CHAPTER 5

Tribal Responses

This chapter contains the Tribal comment letters received on the Pacific Gas and Electric Company (PG&E) Topock Compressor Station Final Groundwater Remediation Project (Final Groundwater Remedy Project, or proposed Project) draft subsequent environmental impact report (Draft SEIR) and the California Department of Toxic Substances Control's (DTSC's) individual responses to significant environmental issues raised in those comments (CEQA Guidelines, Section 15088). Each letter, as well as each individual comment within the letter, has been given an assigned letter and number for cross-referencing. In some instances, Master Responses presented in Chapter 2 of this final subsequent environmental impact report (Final SEIR) may be referenced in response to comments. Responses are sequenced to reflect the order of comments within each letter. **Table 5-1** lists all Tribal governments who submitted comments on the Final Groundwater Remedy Project Draft SEIR during the public review period.

**RE: Draft Subsequent Environmental Impact Report for the PG&E Topock Compressor Station
Final Groundwater Remediation Project
SCH# 2008051003**

Figure 2 Topock Project water supply wells, superimposed on illustration – from Kimley-Horn Final Drainage Report for Sacramento Wash Offsite Improvements (August 2016)

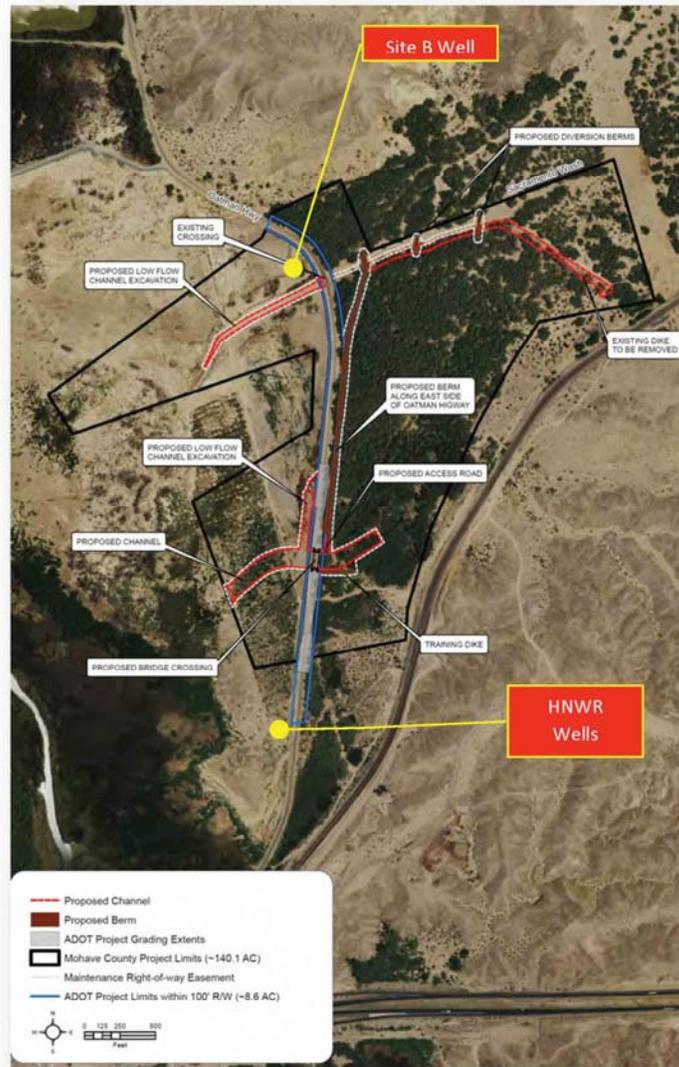
Realistic Flood Impacts. Second, flood magnitude estimates developed as part of the design have a bearing on the assessment of flood hazards or potential damage to Topock Project infrastructure, specifically the Site B and HNWR wells and related infrastructure, on the Arizona side of the Colorado River. See Figure 2, below. ADOT consultant Kimley-Horn used an existing 2D hydraulic model to simulate hydraulic response to a fairly small 2-yr, 30-minute storm event (see Figure 3, below). Relative to Topock Remediation System operation time-frame this is very short. To better assess the extent and magnitude of flooding, and associated erosion and deposition near critical freshwater source wells, Site B and HNWR wells, these simulations should consider a range of possible floods for example, ranging from the 25-yr storm event to the 100-yr storm event. These longer recurrence interval events are more realistic and well within the timeframe associated with PG&E design/operation of remediation system (i.e., 30 – 100 + years). The flow for the 100-yr 24-hr storm is estimated in the Oatman Highway drainage reports to be in the range of 50,000 to 90,000 cfs, depending on the method used, whereas the 2-yr 30-minute flow is only 3,200 cfs. (To get a sense for a 50,000 cfs flow, link here to a video of such a flow at Cow Swim, Desolation Canyon, Green River, Utah: https://www.youtube.com/watch?v=s0MYj7I6_gw.) Approximate inundation mapping (showing the lateral extent of flooding) for the area was developed by the Federal Emergency Response Agency (FEMA) as part of its Flood Insurance Rate Map (FIRM) development for the area – see Figure 4, below.

PG&E and its consultants should conduct a more formal evaluation of longer-term effects of flooding along Sacramento Wash with the new ADOT design and all potential impacts to the Topock Remediation System infrastructure/operation. In addition, PG&E and its consultants should also develop a contingency plan in the event critical remediation system components are impacted by flooding or related sediment deposition. Specifically, PG&E and their consultants should conduct a hydrologic and hydraulic modeling analysis similar to the ADOT- and MCPWD-chartered studies for the Oatman Highway Sacramento Wash crossing project. They should evaluate flooding impacts, soil erosion, scour and deposition impacts and impacts on groundwater flow and water quality using longer design storm recurrence intervals, i.e., 10, 25, 50 & 100 years, on key Topock Project infrastructure and operations. For example, over a 30-year time period, the 10-yr flood has a 96% chance, the 50-yr flood has a 45% chance, and the 100-yr flood has a 26% chance of occurring (FEMA publication 480, 2005, p. 3-5).

The reasonableness of the current design can be derived from examining Figure 2 of the Supporting Information of Attachment A in Comment T3, which shows the proposed ADOT and Mohave County Public Works Department project would construct channels to more efficiently route flood waters away from the Oatman Highway and toward the Colorado River. While the resolution of this figure is relatively poor, it shows the results from a non-regulatory 2D hydraulic model, and presents a 2-year 30-minute storm with an approximate depth of water between 0.1 to 1.1 feet for the HNWR-1 well site at the downstream end of the Sacramento Wash (approximately 1,200 feet downstream of the new ADOT bridge). The remedy infrastructure at HNWR-1A will thus be above the 2-year approximation elevation displayed in Figure 2. Therefore, while the area of the freshwater wells may occasionally be subjected to a flood, as indicated in Appendix IS of the SEIR, the impact would not result in new significant impacts or substantially increase the severity of significant impacts previously identified in the Groundwater FEIR. In the unlikely event of a flood event specifically at the freshwater wells, the wells would be too small to impede or redirect the flow of the flood and could easily be repaired in the unlikely event of surface damage to the wellhead.

Figure 5 Regional map showing area (red circle) upstream of Oatman Wash Sacramento Wash crossing project (round blue marker). Image extract from ArcMap with USGS 7.5-minute quadrangle base mapping.

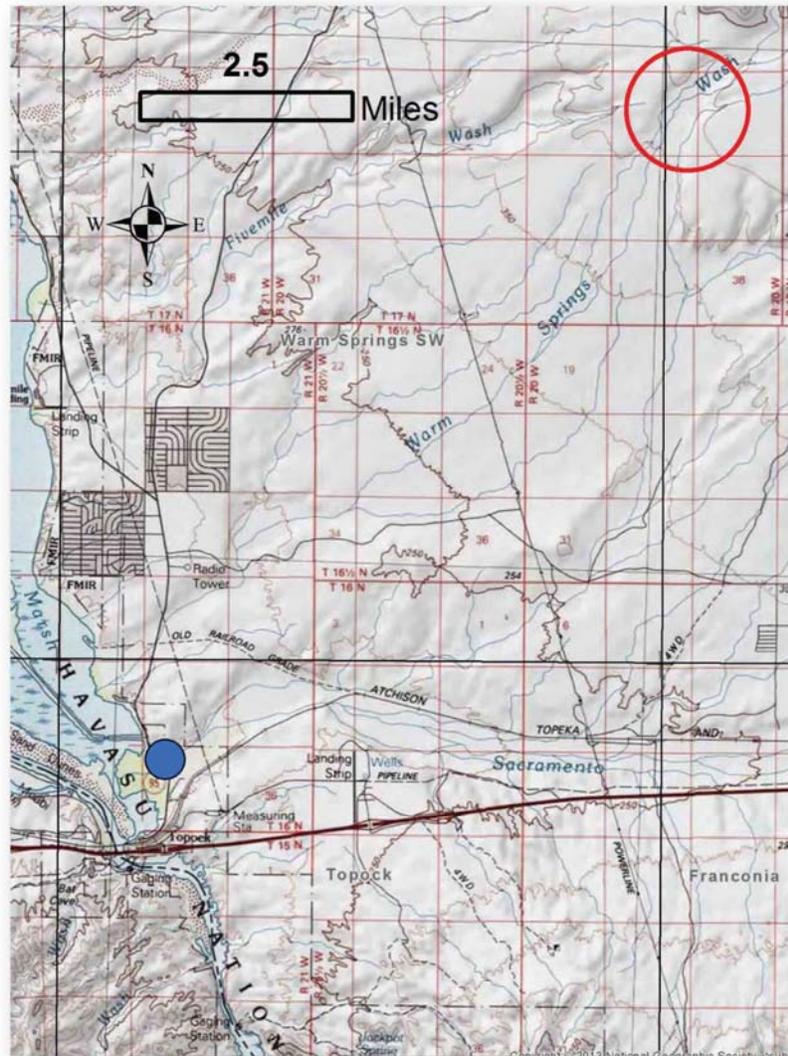
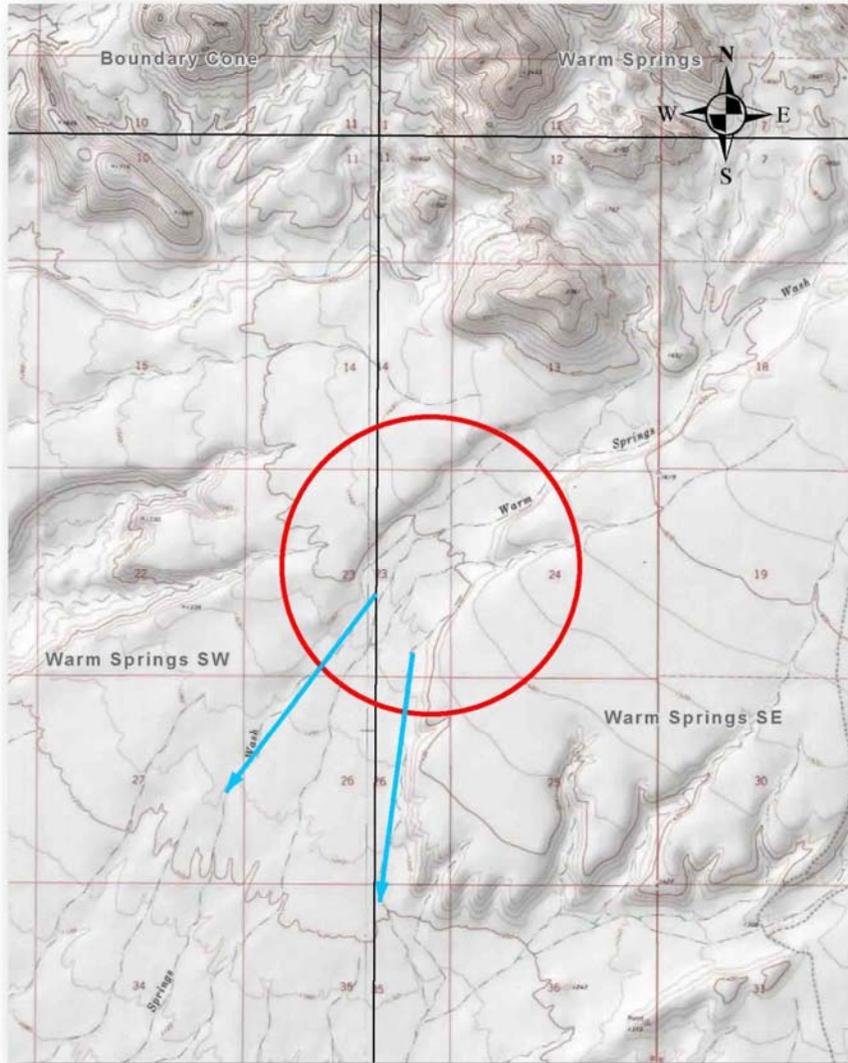
PG&E and its consultants should also consider that approximately 10 miles to the northeast of the Oatman Highway Sacramento Wash crossing project, the southern-most tributary to Warm Springs Wash (the drainage coming from Warm Springs Canyon) is rather close to a major tributary to Sacramento Wash. See Figures 5 & 6. With respect to Figure 6, this is in the area of Sections 23, 24 & 26, Township 17N Range 20W – near the boundary between USGS 7.5-minute quadrangle maps Warm Springs West and Warm Springs East. In this area channels are braided and meandering, apparently without significant intervening topography. Under certain circumstances, one tributary could coalesce with the other, further exacerbating flooding in the lower Sacramento Wash (and freshwater well) area. In the instance where the Warm Springs Wash tributary is captured by the Sacramento Wash tributary, the Sacramento Wash watershed area would increase by an estimated 30+ square miles of high elevation terrain. This could have a major additional impact on flooding in Sacramento Wash, particularly for more localized intense rainfall events. It is unclear whether ADOT or MCPWD considered this in their evaluations. However, a prudent risk analysis would consider this possibility.

Figure 2 Topock Project water supply wells, superimposed on illustration – from Kimley-Horn Final Drainage Report for Sacramento Wash Offsite Improvements (August 2016)

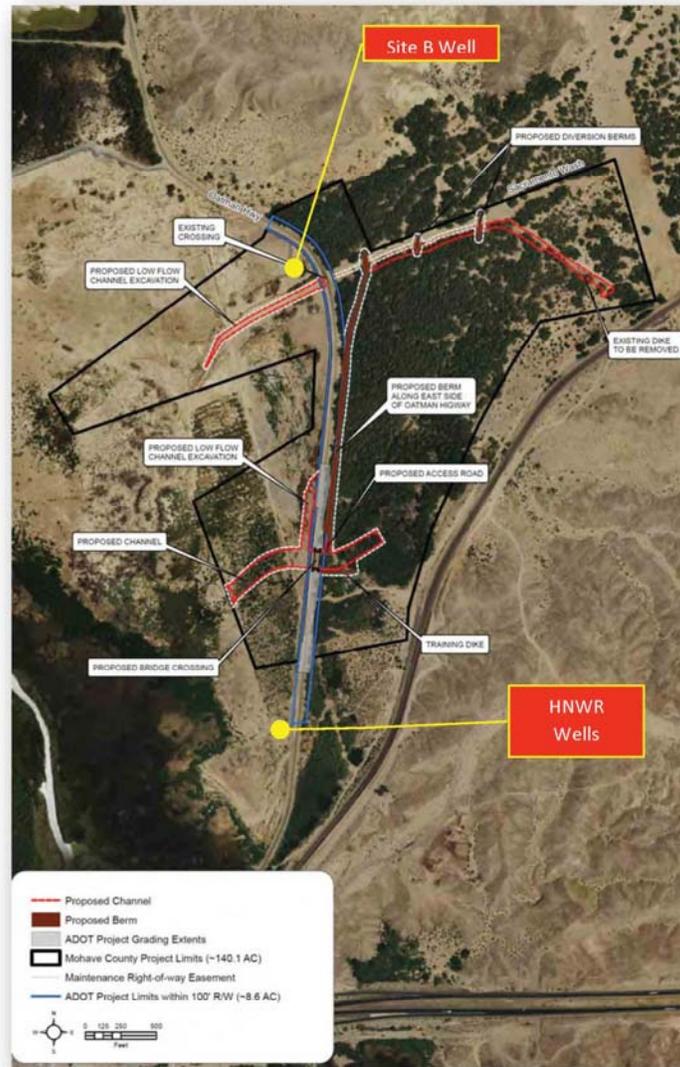
Realistic Flood Impacts. Second, flood magnitude estimates developed as part of the design have a bearing on the assessment of flood hazards or potential damage to Topock Project infrastructure, specifically the Site B and HNWR wells and related infrastructure, on the Arizona side of the Colorado River. See Figure 2, below. ADOT consultant Kimley-Horn used an existing 2D hydraulic model to simulate hydraulic response to a fairly small 2-yr, 30-minute storm event (see Figure 3, below). Relative to Topock Remediation System operation time-frame this is very short. To better assess the extent and magnitude of flooding, and associated erosion and deposition near critical freshwater source wells, Site B and HNWR wells, these simulations should consider a range of possible floods for example, ranging from the 25-yr storm event to the 100-yr storm event. These longer recurrence interval events are more realistic and well within the timeframe associated with PG&E design/operation of remediation system (i.e., 30 – 100 + years). The flow for the 100-yr 24-hr storm is estimated in the Oatman Highway drainage reports to be in the range of 50,000 to 90,000 cfs, depending on the method used, whereas the 2-yr 30-minute flow is only 3,200 cfs. (To get a sense for a 50,000 cfs flow, link here to a video of such a flow at Cow Swim, Desolation Canyon, Green River, Utah: https://www.youtube.com/watch?v=s0MYj7I6_gw.) Approximate inundation mapping (showing the lateral extent of flooding) for the area was developed by the Federal Emergency Response Agency (FEMA) as part of its Flood Insurance Rate Map (FIRM) development for the area – see Figure 4, below.

The reasonableness of the current design can be derived from examining Figure 2 of the Supporting Information of Attachment A in Comment T3, which shows the proposed ADOT and MCPWD project would construct channels to more efficiently route flood waters away from the Oatman Highway and toward the Colorado River. While the resolution of this figure is relatively poor, it shows the results from a non-regulatory 2D

hydraulic model, and presents a 2-year 30-minute storm with an approximate depth of water between 0.1 to 1.1 feet for the HNWR-1 well site at the downstream end of the Sacramento Wash (approximately 1,200 feet downstream of the new ADOT bridge). The remedy infrastructure at HNWR-1A will thus be above the 2-year approximation elevation displayed in Figure 2. Therefore, while the area of the freshwater wells may occasionally be subjected to a flood, as indicated in Appendix IS of the SEIR, the impact would not result in new significant impacts or substantially increase the severity of significant impacts previously identified in the Groundwater FEIR. In the unlikely event of a flood event specifically at the freshwater wells, the wells would be too small to impede or redirect the flow of the flood and could easily be repaired in the unlikely event of surface damage to the wellhead.

The reasonableness of the current design can be derived from examining Figure 2 of the Supporting Information of Attachment A in Comment T3, which shows the proposed ADOT and MCPWD project would construct channels to more efficiently route flood waters away from the Oatman Highway and toward the Colorado River. While the resolution of this figure is relatively poor, it shows the results from a non-regulatory 2D hydraulic model, and presents a 2-year 30-minute storm with an approximate depth of water between 0.1 to 1.1 feet for the HNWR-1 well site at the downstream end of the Sacramento Wash (approximately 1,200 feet downstream of the new ADOT bridge). The remedy infrastructure at HNWR-1A will thus be above the 2-year approximation elevation displayed in Figure 2. Therefore, while the area of the freshwater wells may occasionally be subjected to a flood, as indicated in Appendix IS of the SEIR, the impact would not result in new significant impacts or substantially increase the severity of significant impacts previously identified in the Groundwater FEIR. In the unlikely event of a flood event specifically at the freshwater wells, the wells would be too small to impede or redirect the flow of the flood and could easily be repaired in the unlikely event of surface damage to the wellhead.

Figure 5 Regional map showing area (red circle) upstream of Oatman Wash Sacramento Wash crossing project (round blue marker). Image extract from ArcMap with USGS 7.5-minute quadrangle base mapping.

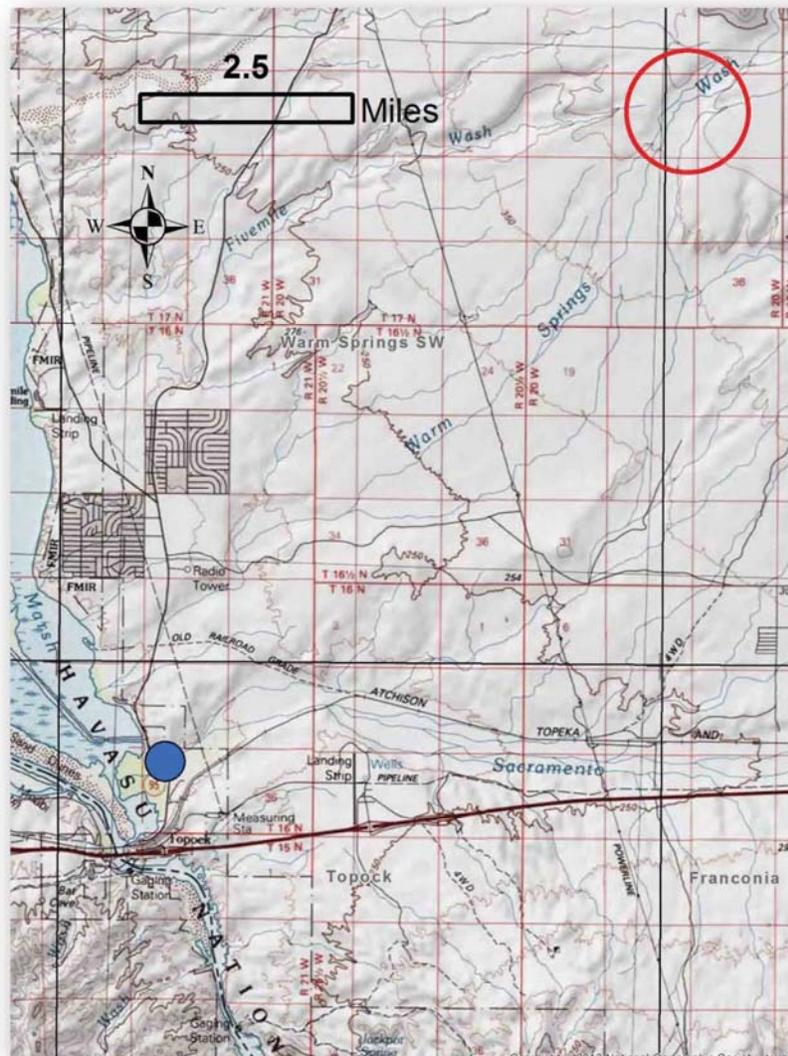
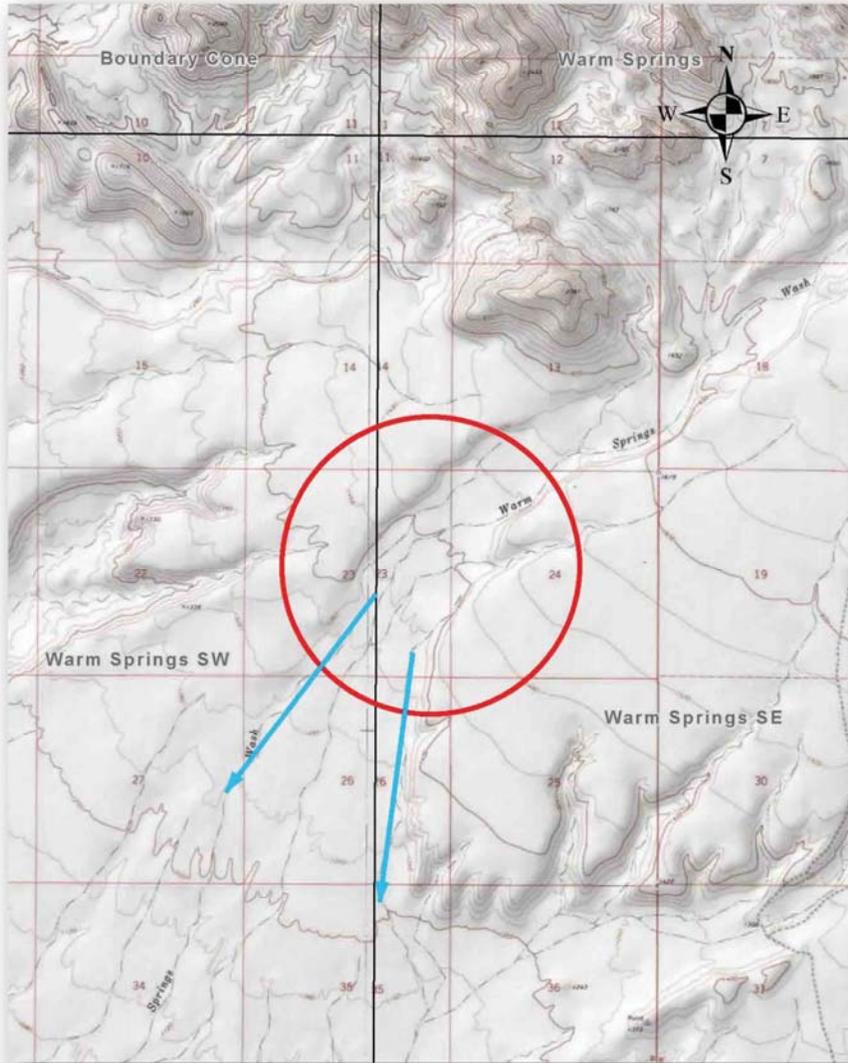
PG&E and its consultants should also consider that approximately 10 miles to the northeast of the Oatman Highway Sacramento Wash crossing project, the southern-most tributary to Warm Springs Wash (the drainage coming from Warm Springs Canyon) is rather close to a major tributary to Sacramento Wash. See Figures 5 & 6. With respect to Figure 6, this is in the area of Sections 23, 24 & 26, Township 17N Range 20W – near the boundary between USGS 7.5-minute quadrangle maps Warm Springs West and Warm Springs East. In this area channels are braided and meandering, apparently without significant intervening topography. Under certain circumstances, one tributary could coalesce with the other, further exacerbating flooding in the lower Sacramento Wash (and freshwater well) area. In the instance where the Warm Springs Wash tributary is captured by the Sacramento Wash tributary, the Sacramento Wash watershed area would increase by an estimated 30+ square miles of high elevation terrain. This could have a major additional impact on flooding in Sacramento Wash, particularly for more localized intense rainfall events. It is unclear whether ADOT or MCPWD considered this in their evaluations. However, a prudent risk analysis would consider this possibility.
